Planning and Zoning Special Meeting AGENDA

STAFF REPORT
KETCHUM PLANNING AND ZONING COMMISSION
REGULAR MEETING OF AUGUST 13, 2019

PROJECT: Mountain Land Design Showroom

FILE NUMBER: P19-075

C1.0

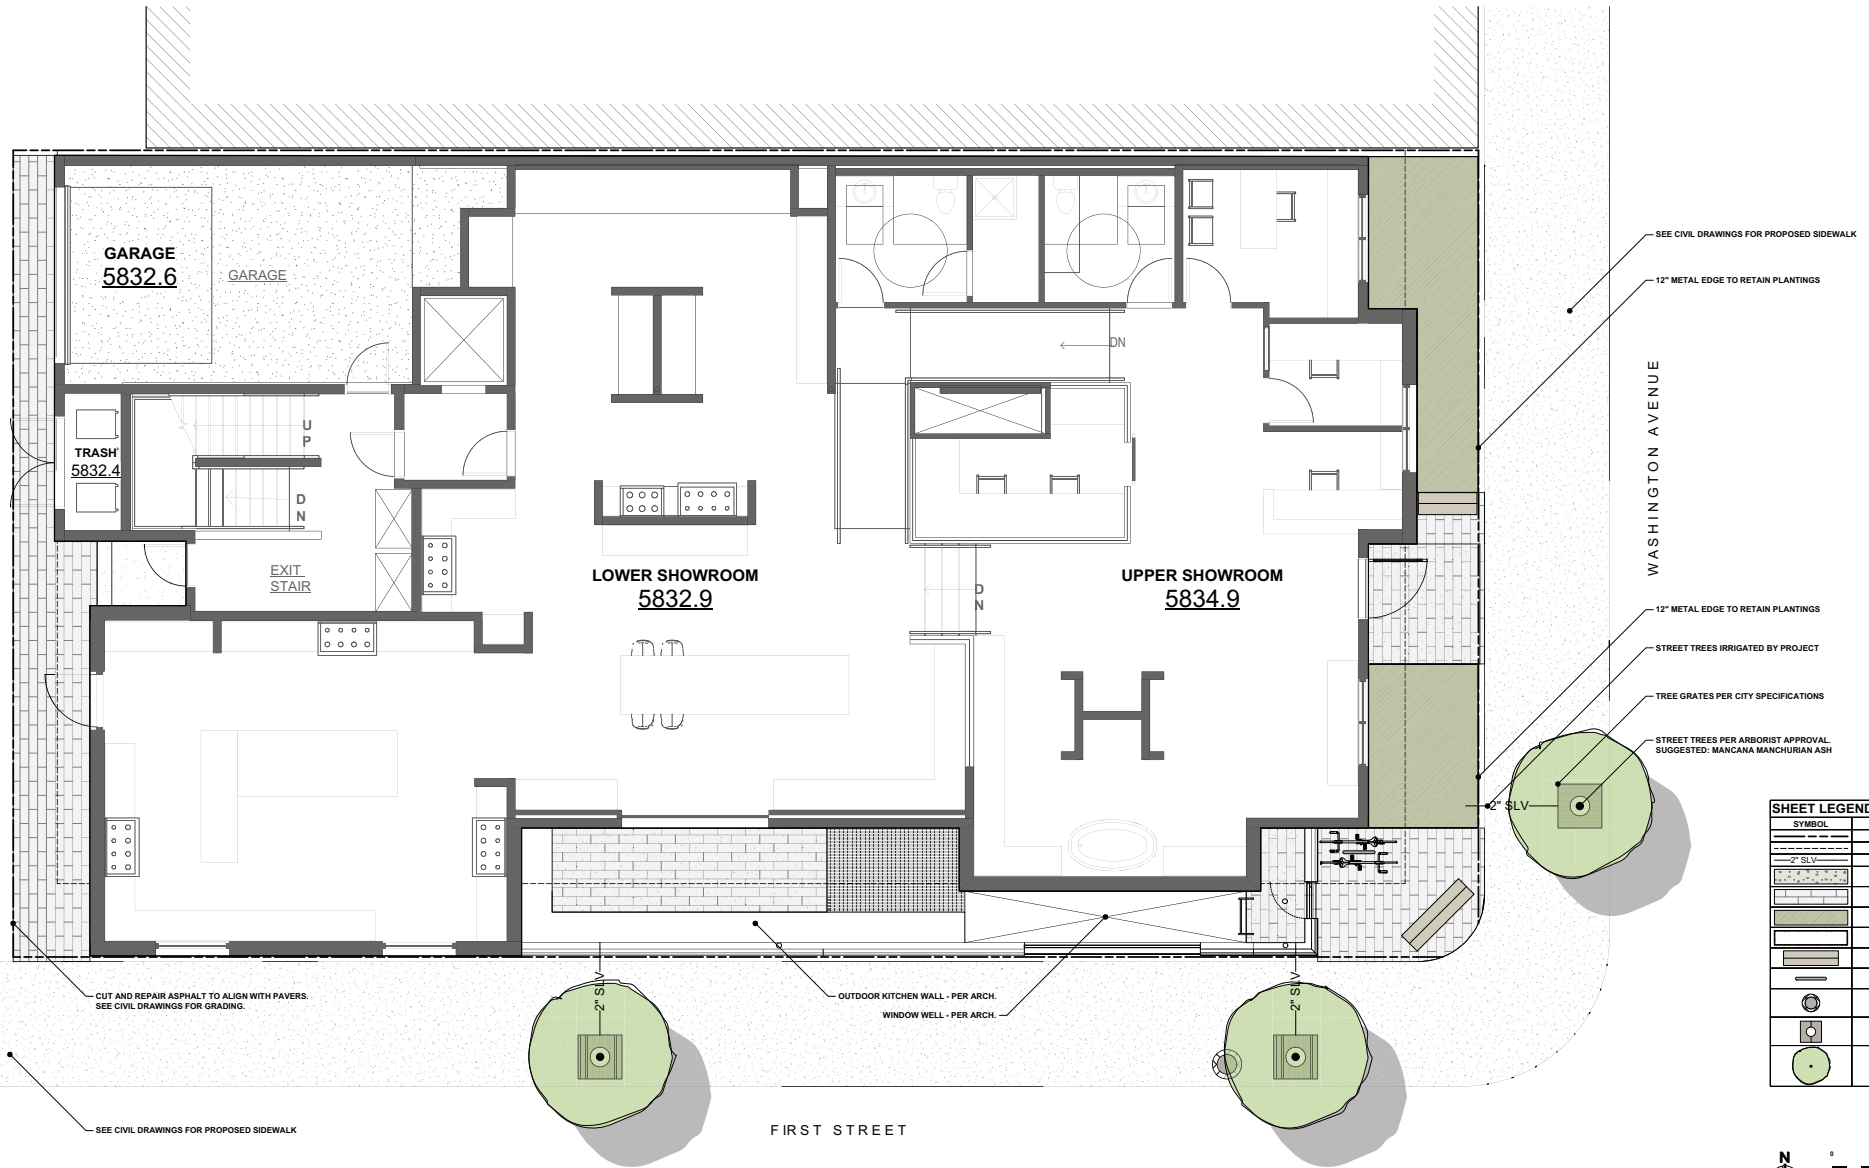
| | | | Staff Comments | <i>Sidewalks exist but are planned to be upgraded to meet current city standard. See Civil sheet C1.0</i> |
| | | | Staff Comments | <i>All stormwater is proposed to be retained on site. See Civil sheet C1.0. The City Engineer has indicated that additional detail related to storm water management will be required at time of building permit review (e.g. Comment #1, all roof drain locations need to be shown on plans and roof drain stormwater must be retained on site).</i> |

SITE / LANDSCAPE PLAN
SCALE: 1/8" = 1'-0"

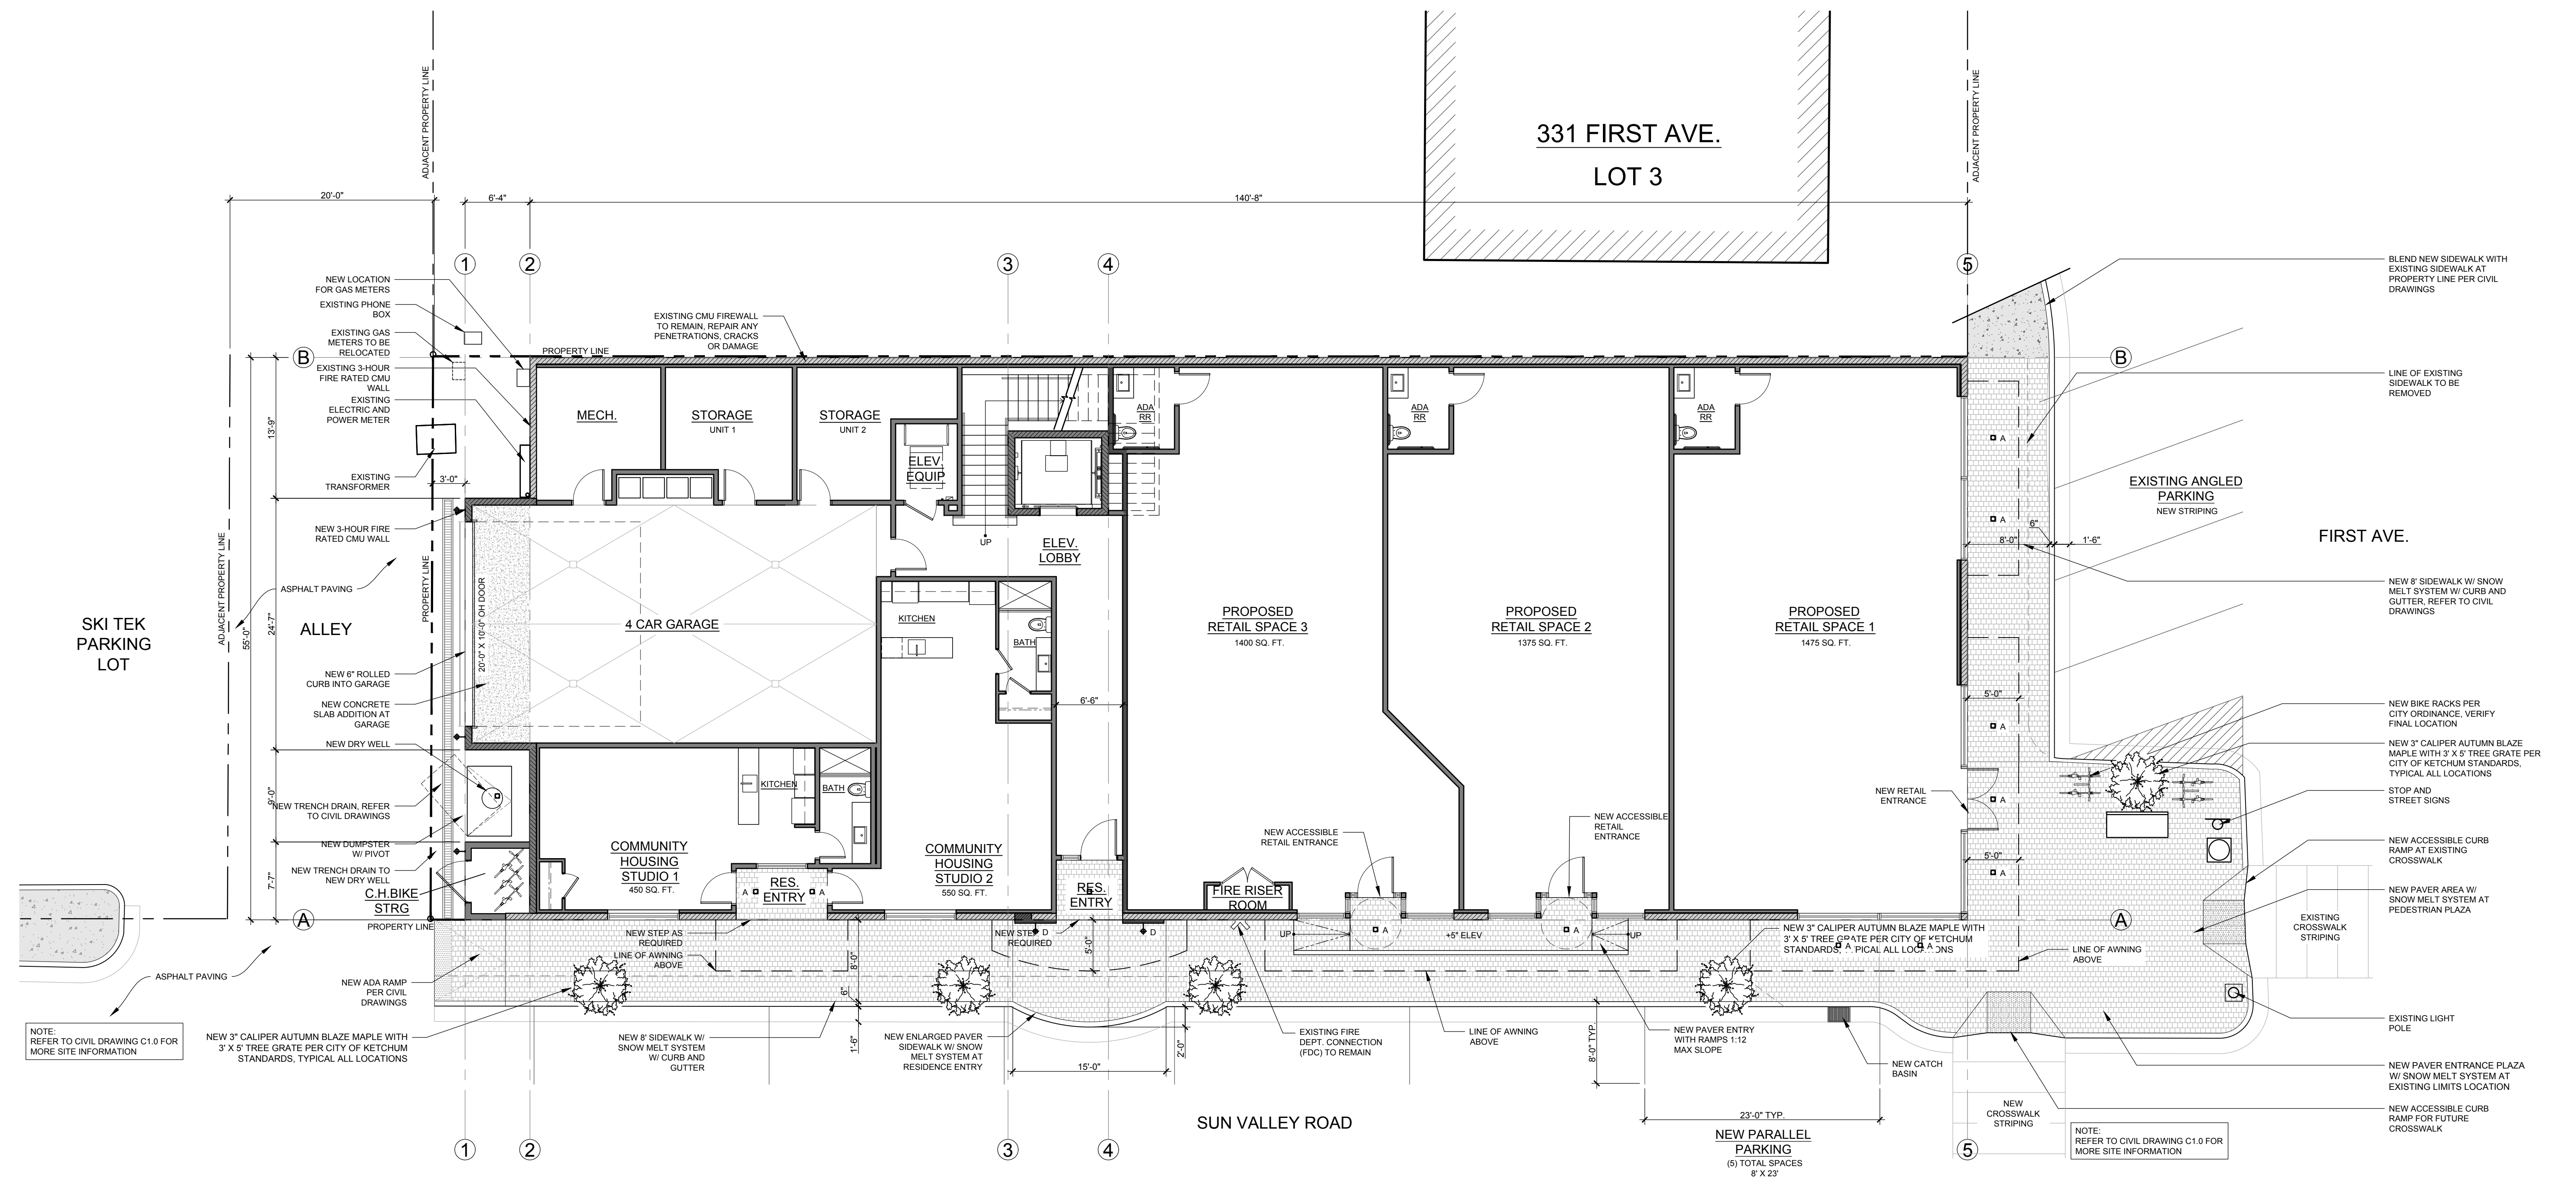
| | | | <i>Staff Comments</i> | <i>The garbage storage area, indicated on Sheet A0.1, is located off the alley and includes a pivot system. The applicant shall submit a will-serve letter from Clear Creek Disposal prior to issuance of a Building Permit for the project.</i> |
| | | | <i>Staff Comments</i> | <i>The proposed mixed-use building provides unobstructed pedestrian access to the proposed improved sidewalks adjacent to 1st Avenue and Sun Valley Road. As noted on Sheet A0.1 and C1.0, the sidewalk design will connect with existing sidewalks along 1st Avenue and Sun valley Road.</i> |

| | | | <i>Staff Comments</i> | <i>The landscape plan is included on Sheet A0.1. The applicant has proposed 5 street trees, which are specified as 3" caliper autumn blaze maples. All street trees will require electrical outlets and irrigation. The applicant has also proposed planters at the rooftop terrace.</i> |

MAIN LEVEL FLOOR PLAN - PROPOSED

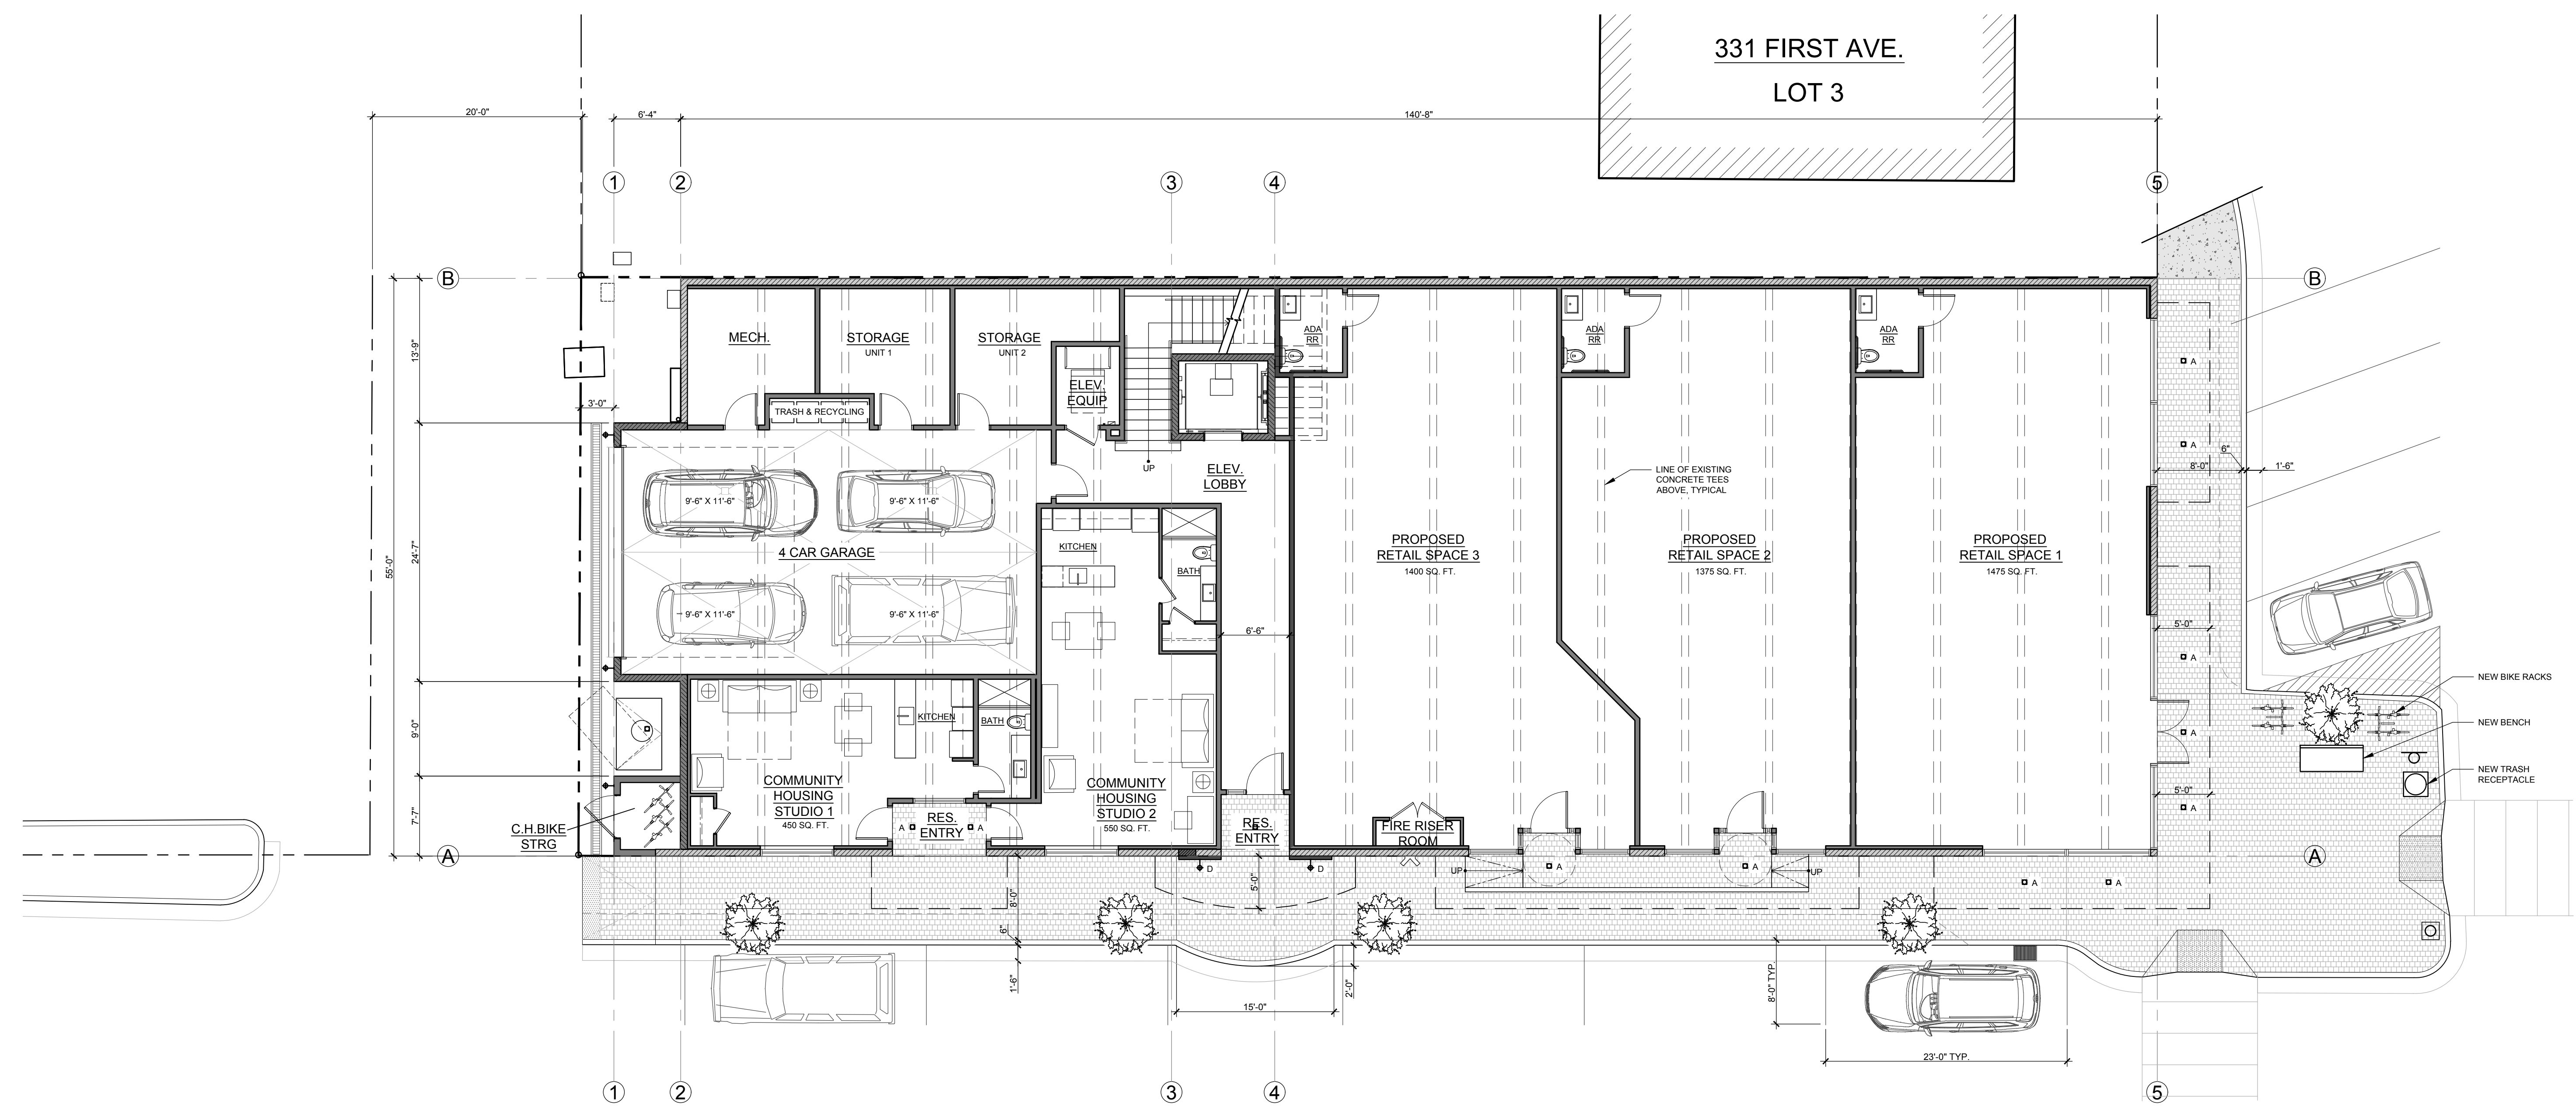
| | | | <i>Staff Comments</i> | <i>As indicated on Sheet A2.0, the applicant has proposed new bike racks, a bench, and trash receptacle within a proposed bulb out. The corner layout of 1st and SV Road and entrance bulb out shown the Design Review plans does not meet City Standards and is not approved as proposed. Bulb outs are not a City Standard, but may be considered on a case by case basis. Applicant will need to fill out a design exception request and provide a sketch or drawing of the proposed bulb out design prior to Building Permit application submittal. Design exception requests will be distributed internally for to City Departments for review and consideration. The siting of public amenities within the public ROW require review and approval by the City Engineer and Streets Department prior to issuance of a Building Permit for the project.</i> |

ROOF DECK PLAN - PROPOSED
 SCALE: 1/8" = 1'-0"

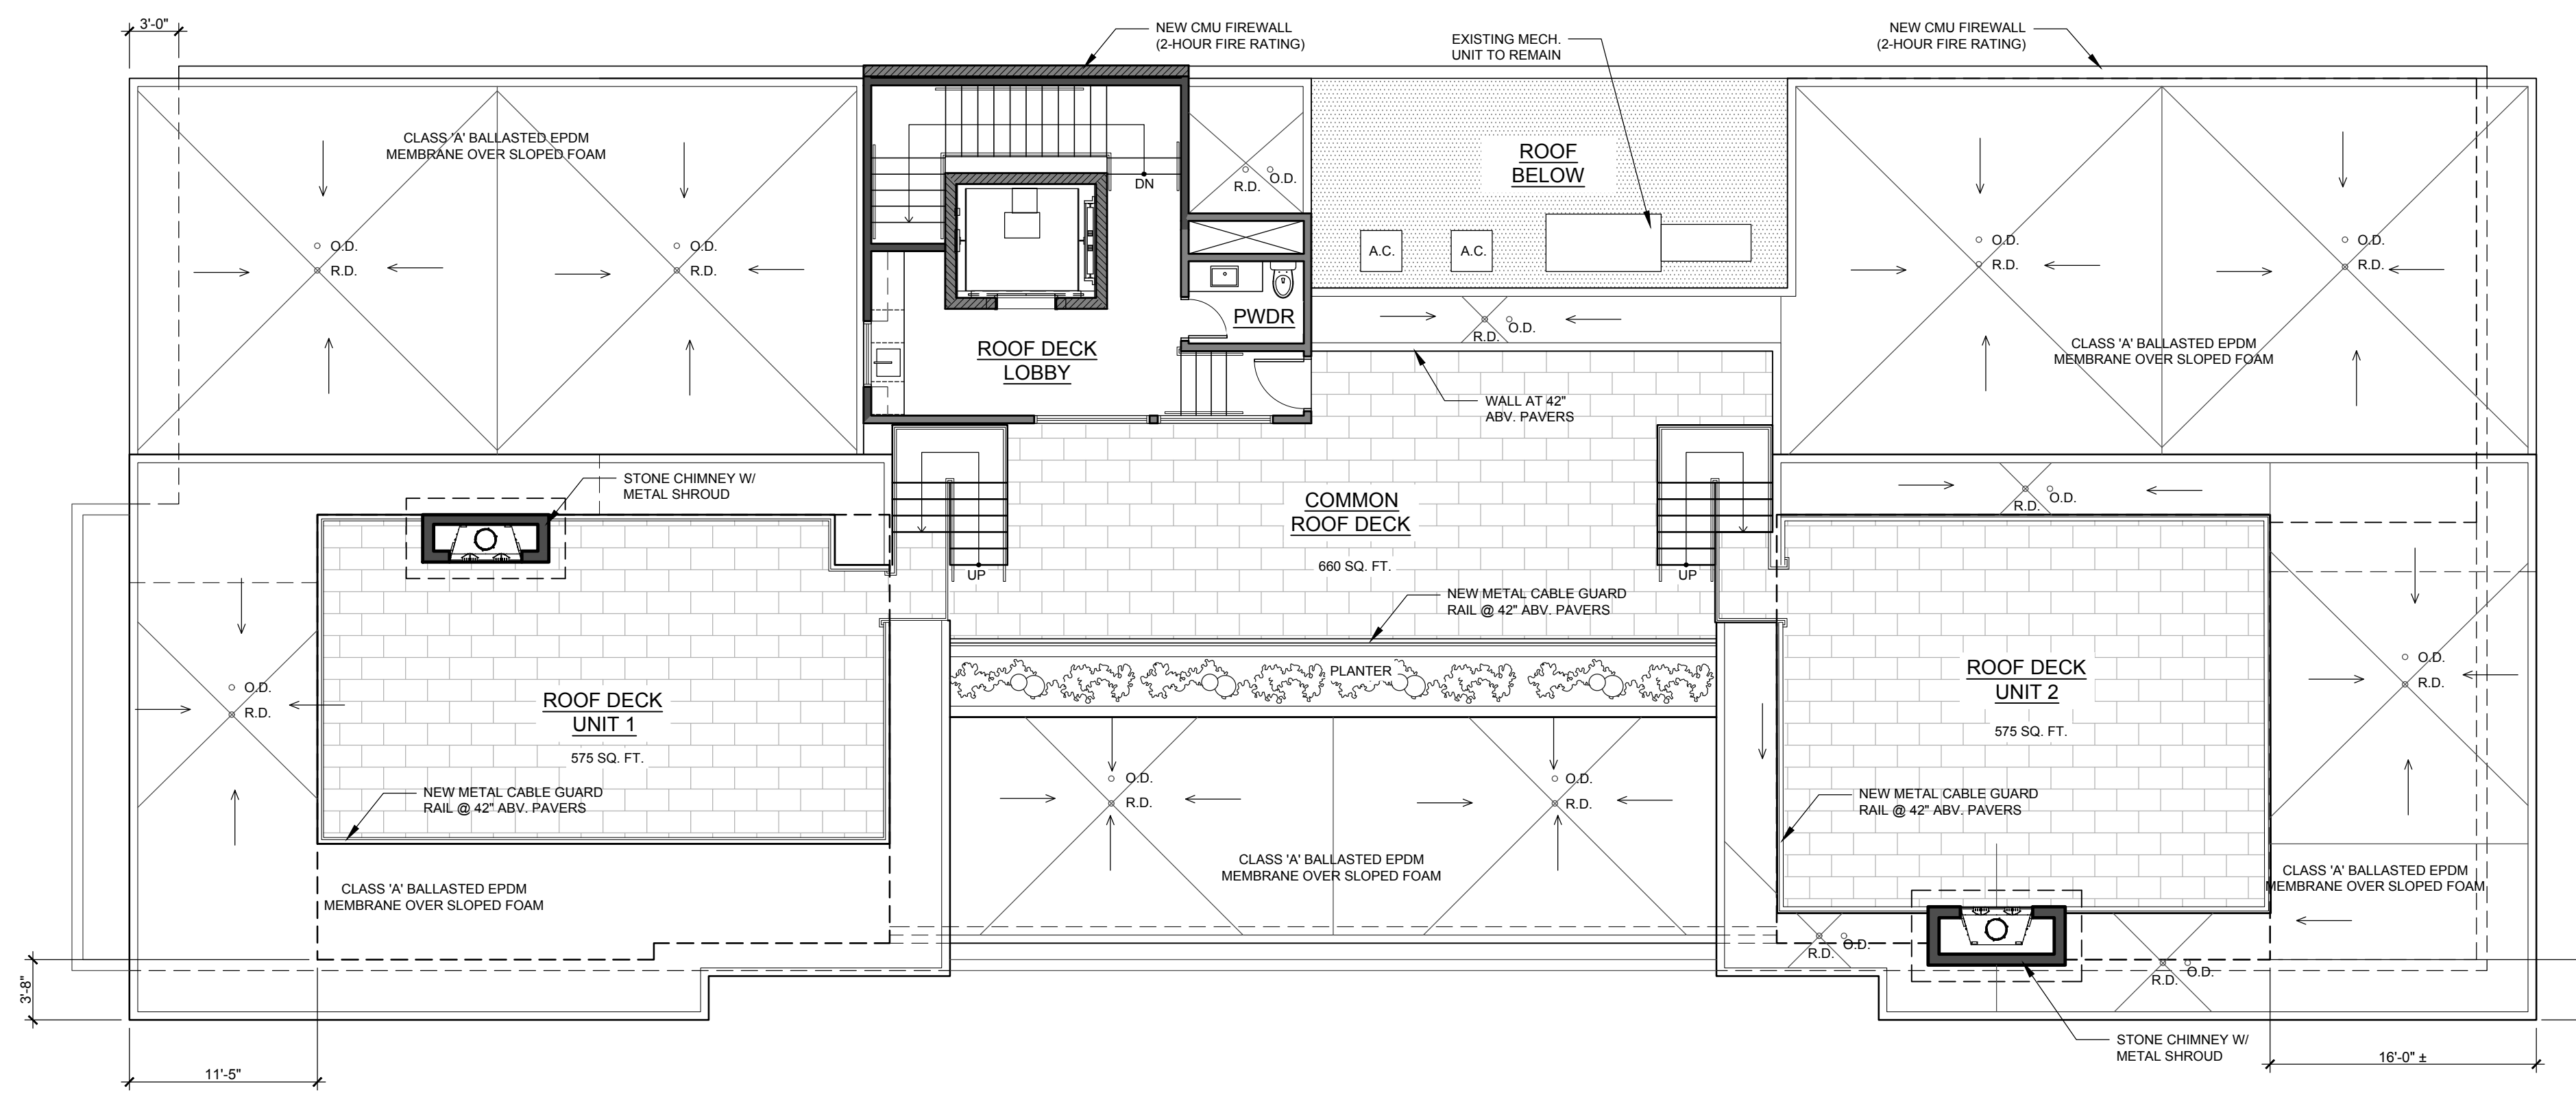
| | | | <i>Staff Comments</i> | <i>The proposed design of the mixed-use building incorporates a flat roof. As indicated on Sheet A2.1 the roofing material is proposed to be a Class "A" ballasted EPDM membrane. Reflective materials are prohibited.</i> |
